ARCHITECTURAL REVIEW BOARD STAFF REPORT

Project #/Name	**ARB-2020-73: 2415 Ivy Road Final Site Plan Review**
Review Type	Final Site Development Plan Review/Comprehensive Sign Review
Parcel Identification	060000000025A0
Location	2415 Ivy Road near the intersection of Canterbury Road (Figure 1)
Zoned	Commercial (C1)/Entrance Corridor (EC)/Airport Impact Area (AIA)/Steep Slopes - Managed
Owner/Applicant	JPA Tower Investors, LLC/Clark Gathright
Magisterial District	Samuel Miller
Proposal	To renovate 10,000 sf of the street-facing end of the existing commercial building for retail use.
Context	2415 Ivy Road is part of a small group of buildings (including 2405, 2409 and 2411) originally constructed as a John Deere dealership. This portion of Ivy Road is a mixture of commercial and residential uses. A golf course is to the southwest. The commercial buildings in the vicinity are one and two stories tall.
Visibility	The south, east and west sides of the building are clearly visible from the EC (Ivy Road). The building is 68’ from the right-of-way and 82’ from the curb.

ARB Meeting Date	September 21, 2020
Staff Contact	Khris Taggart

GAS METER ENCLOSURE DETAIL

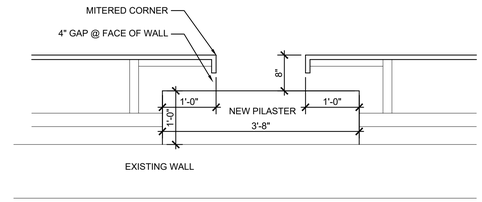
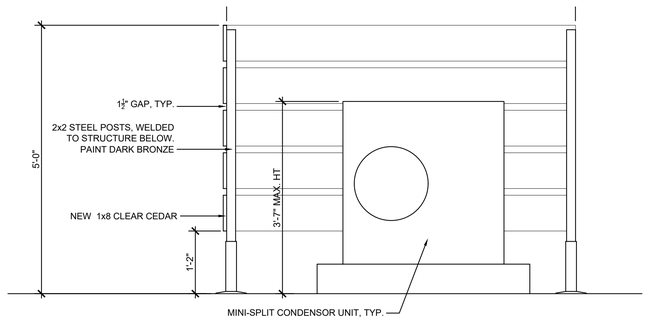
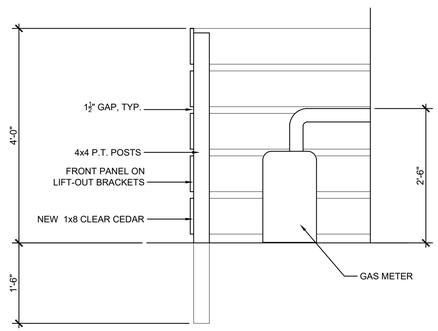
17	Accessory structures and equipment should be integrated into the overall plan of development and shall, to the extent possible, be compatible with the building designs used on the site.	Revise the rooftop equipment screen lengths and locations to support the building design while screening all possible equipment locations. Show the locations of the proposed gas meter and water utility box, and ensure that they are not visible from the EC.	The plans have been revised to indicate that the maximum height of the proposed roof-mounted equipment will be 3'. The proposed 5' screens will adequately screen the mechanical equipment. The mechanical equipment screen design has been revised. Two screens of equal length and color matching the sign screens are symmetrically located in line with storefront bays (as viewed in elevation). This is expected to create an appropriate appearance. An existing gas meter is shown near the southeast corner of the building. The gas meter is proposed to be screened by a 4' enclosure to match the sign and mechanical screens. However, it is unclear if the enclosure will have a coordinated appearance with the other proposed changes along the façade.	Provide details on the gas meter enclosure (material and color) to ensure coordination.

1. Provide details on the gas meter enclosure (material and color) to ensure coordination.
2. Revise the plans to remove the references to the stone wall currently included on the Cover Sheet and the Grading and Drainage Plan.

SOUTH ELEVATION

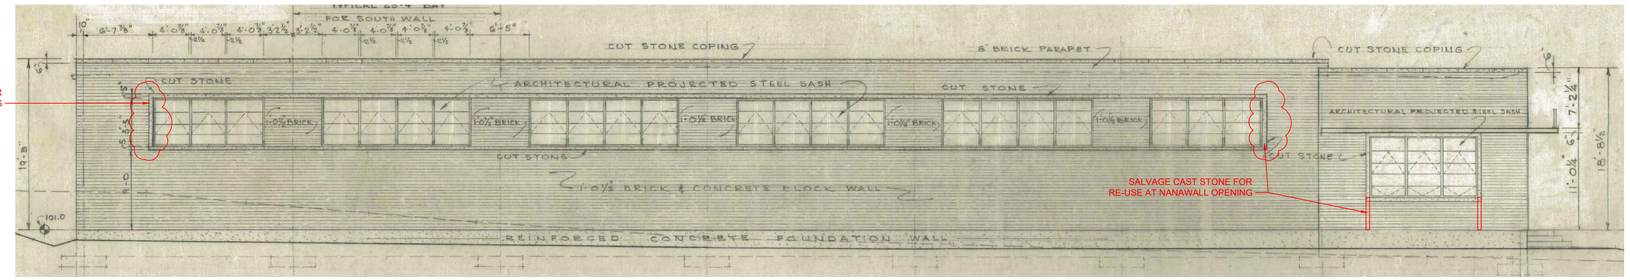
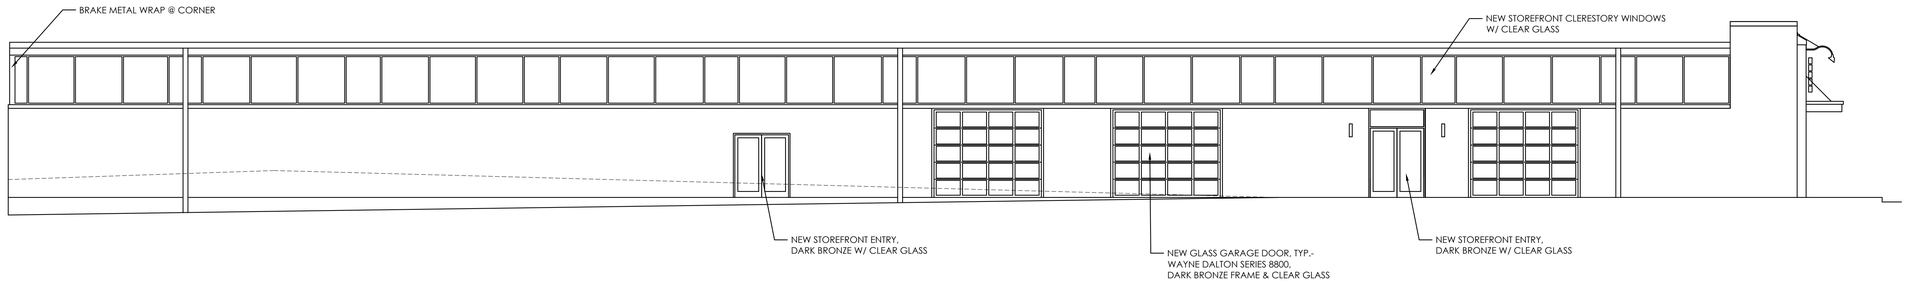
REF	GUIDELINE	ACTIONS 8/3/2020	ISSUES 9/21/20	RECOMMENDATIONS 9/21/20
	Structure design			
1	The goal of the regulation of the design of development within the designated Entrance Corridors is to ensure that new development within the corridors reflects the traditional architecture of the area. Therefore, it is the purpose of ARB review and of these Guidelines, that proposed development within the designated Entrance Corridors reflect elements of design characteristic of the significant historical landmarks, buildings, and structures of the Charlottesville and Albemarle area, and to promote orderly and attractive development within these corridors. Applicants should note that replication of historic structures is neither required nor desired.	Reconsider the color, material and/or size of the sign screen for greater coordination with the building form, with changes to be presented as an "other business" item in a future meeting.	The sign screen design has been revised. The single long screen that was previously proposed has been divided into multiple screens, with each screen extending to adjacent pilasters. The screens are unpainted/painted a darker color. The pilasters are now topped with a stone cap and are visible above the sign screens. These changes allow the brick building to read as the primary architectural element, which is appropriate. (Fig. 2 and 3). On the south end of the façade and along the east elevation the wood screen has been removed from the design. This revision allows for the brick to have a greater presence when viewed from the EC, and provides for a more coordinated appearance overall. (Fig. 4) The south end of façade has also been revised to show a traditional storefront in place of the sliding glass bay door originally proposed. The revision is minimal in nature and has little impact on the overall design (Fig. 2 and 3).	None.
